Fermilab

Radiation Safety Review of Enclosure G2 North Addition

J. D. Cossairt and J. G. Couch
April 1981

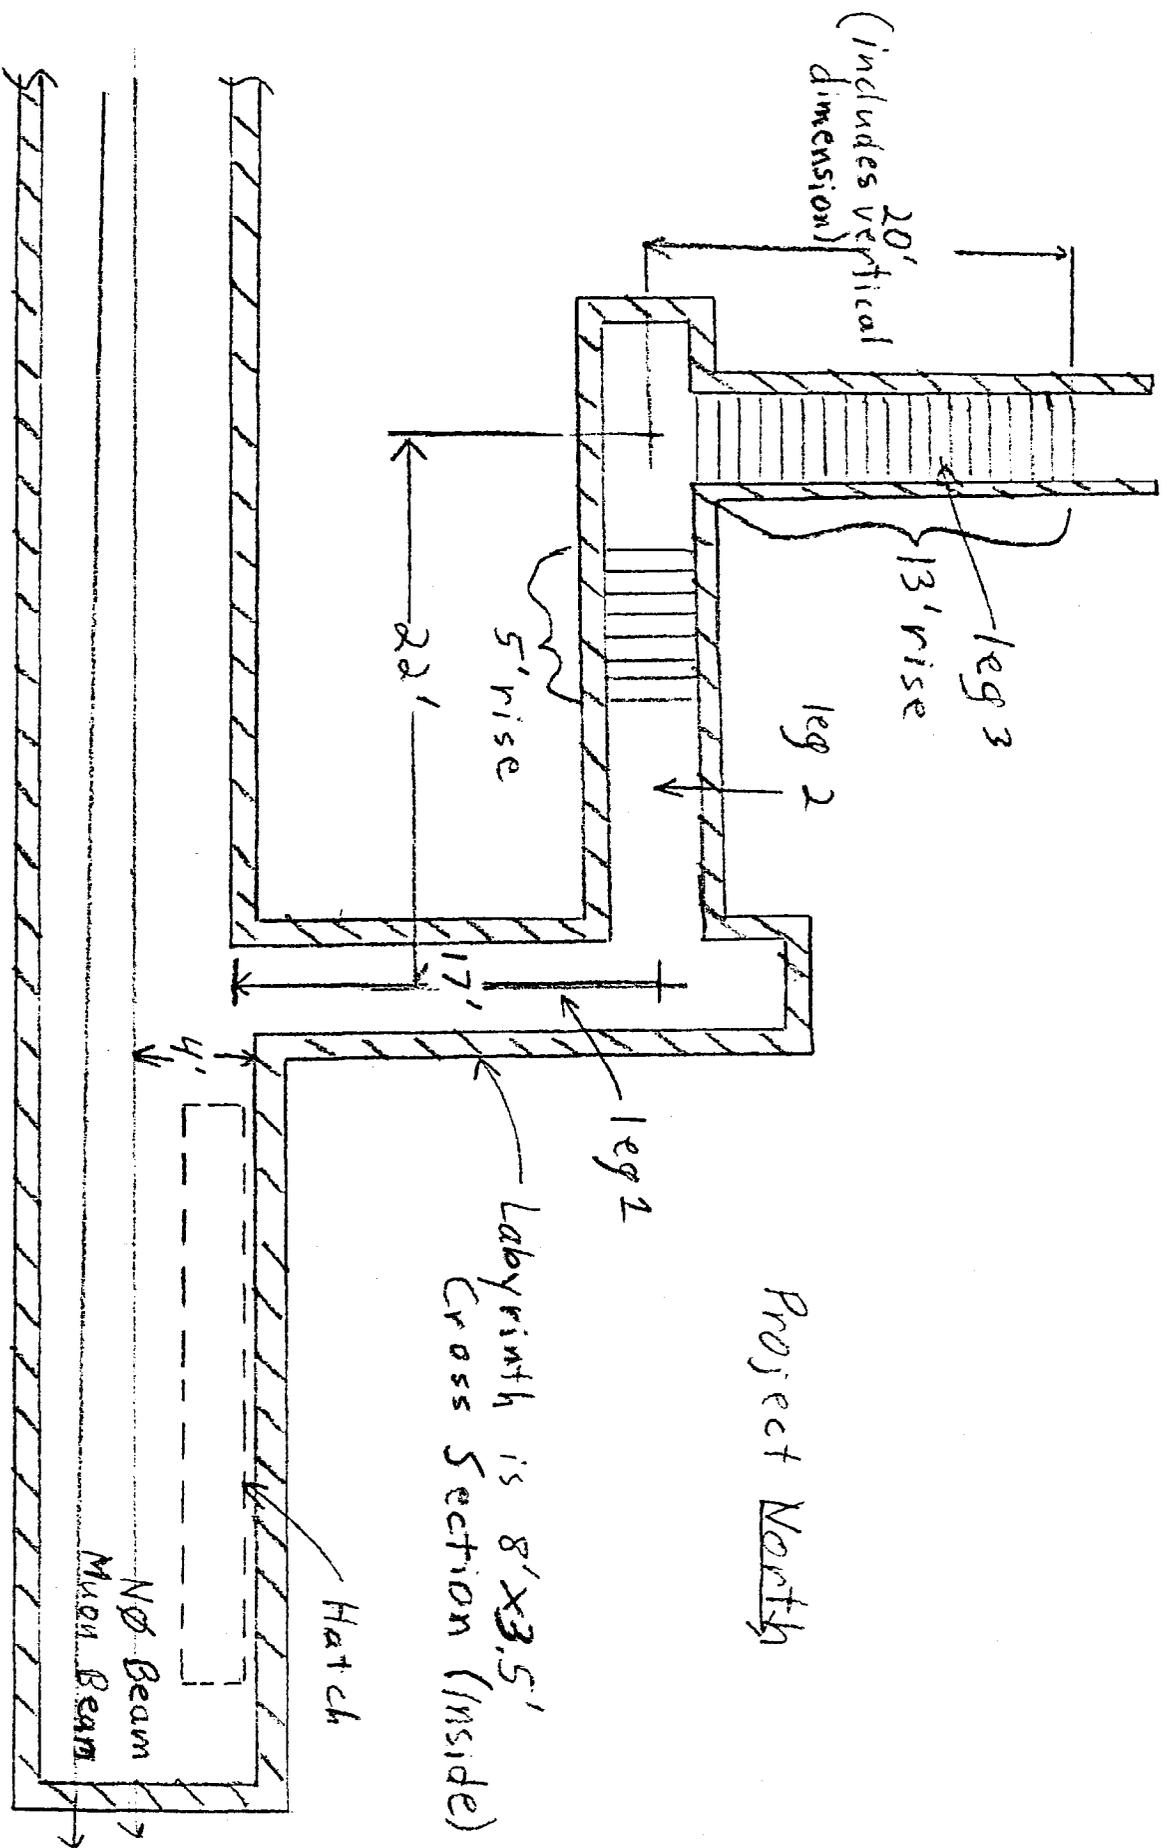
First consider the shielding over the top of the enclosure. As one can see, there is planned to be approximately 17 feet of soil shield plus 1 foot of concrete. Using a value of 2.24 g/cm^2 for the soil density in a compacted berm and 2.4 g/cm^2 for the density of concrete one calculates a total shielding thickness of 16.9' (514 cm) of concrete equivalent shielding. Note that the NØ beam is the closest beam line to the hatch, the surface, and the labyrinth and also handles the highest intensity under the usual operating conditions. Because of some uncertainty in exact locations

pulse at 1000 GeV one then has a 10 mrem/pulse area over the enclosure. A one per cent loss under the above 1000 GeV conditions would represent a dose equivalent of 6 mrem/hr (60 pulses). Fences or interlocked detectors would be advisable under such conditions. The hatch poses no special problem if built as designed. The cracks between the blocks and the walls will act as small labyrinths if the blocks are properly staggered.

Enclosure G2 North Addition - Plan View -
 Downstream End
 Fig 1

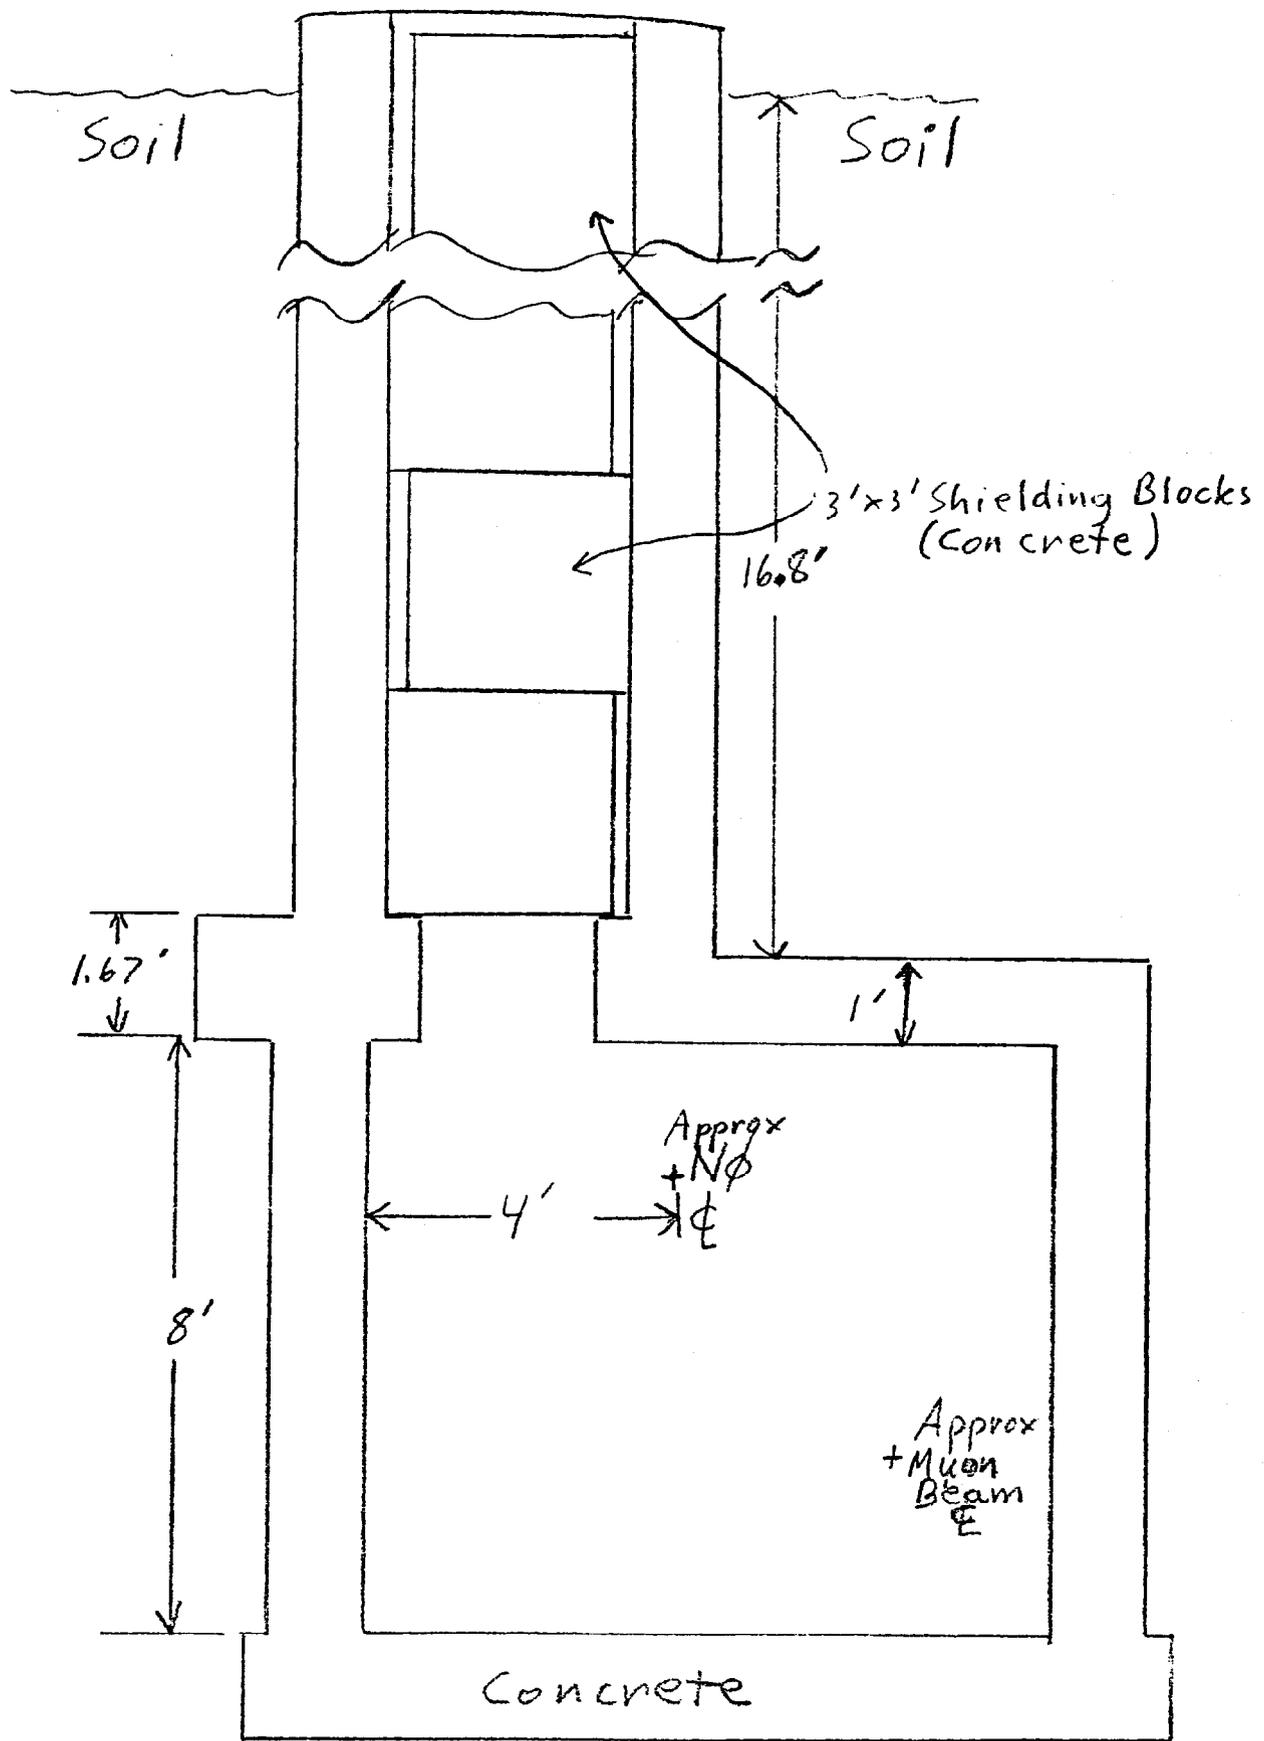
The third major item needing evaluation is the labyrinth. Labyrinth calculations are done following Ref 2. In this case the aperture is 8' x 3.5' so that the unit length \sqrt{A} is 5.3¹. If the source is considered to be a point on the \emptyset beam line, it is then 4' from the mouth of the labyrinth. Using the "one neutron/GeV rule" and 3×10^7 n/cm²·rem, the source term at the mouth is (for various conditions):

From Fig 7 and 8 of Ref 3 we get the following reduction factor for each leg (the interlocked gate is assumed to be at the top of the stairs):

The change in elevation is neglected above but worth perhaps a factor of five so that we have for each operating condition at the top of the stairs:

400 GeV; full: 0.13 mrem/2.5 x 10¹³
400 GeV; 1% loss: 0.4 mrem/hr
1000 GeV; full: 1.3 mrem/10¹⁴
1000 GeV; 1% loss: 0.8 mrem/hr

All of these are acceptable in an area with minimal occupancy.

An additional concern is that the soil cover at the intermediate landing is only 3.3' soil + concrete cover. However, at this location this is adequate because of the softening of the neutron spectrum at this location.
